22/00319/FUL Further Comments
Cllr C Thomas, Ward Member, 8 March 2023

Having had a chance to read the officer report, I offer the following comments.

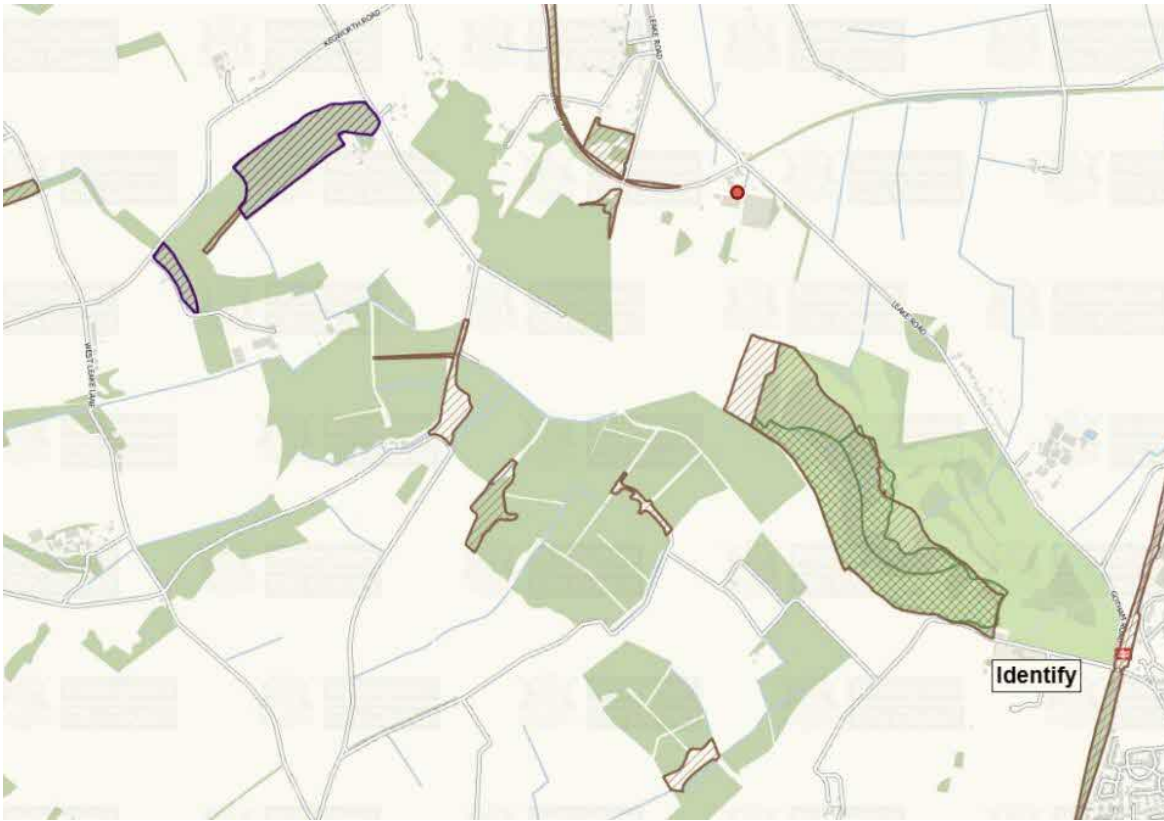
"Within 5 km" significantly underrepresents the situation. The SSSI (Golf Course) adjoins the site. There are seven further local wildlife sites in and around the adjacent woods (Leake New Wood Track, Ash Spinney Assart, Crowend Wood - Eastern and Western Assarts, and Crowend Wood Ride, Court Hill Grassland, Gotham Wood), showing the richness of the habitat here. (See map)

The officer report does not cover consideration of the approved Rushcliffe Nature Conservation Strategy and Biodiversity Action Group. The importance of this 1.5 mile long site as part of an important network of wildlife corridors has not been fully assessed.

Insufficient consideration of the impact on local wildlife sites, wildlife corridors and the relevant strategy is a reason for refusal.

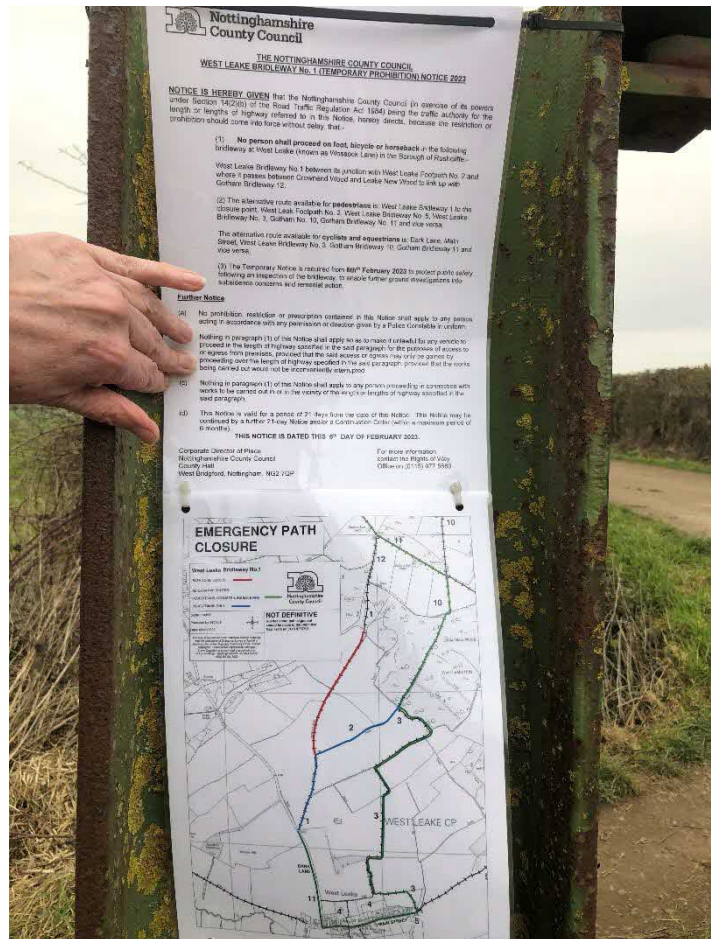
The application as it stands has the areas of solar panels surrounded by “deer fence”. This has the look of an agricultural field stock fence, only higher to prevent deer jumping over. It is specified in the document: Typical Deer Fence - Plan Ref: 04533-RES-SEC-DR-PT-003 (Figure 13 Version 2). The officer report in para 19 states:

(Images above are from the “Typical Deer Fence” document). Note that all the landscape appraisals and photomontages that form part of the application have been for this type of fence.

I would strongly advise to avoid the use of what is described as ‘Deer Fencing’, which is referred to in the DAS on this planning submission, as this does not provide any difficulty or deterrent to the criminal.”

“I would recommend that the boundary fence is to a minimum of LPS 1175 level 3 and to a height of 2.4 metres or to the current UK Government standard, SEAP (Security Equipment Approval Panel) class 1-3. The use of 2.4 metre welded mesh fencing (in green) would be the most unobtrusive method of providing a secure perimeter border.”

In terms of impact on views and the landscape these are clearly two very different scenarios. The officer report para 235 states that this can be dealt with by condition, but I suggest that changing the fence type is a fundamental change and the photomontages would need to be redone and there would need to be another consultation.
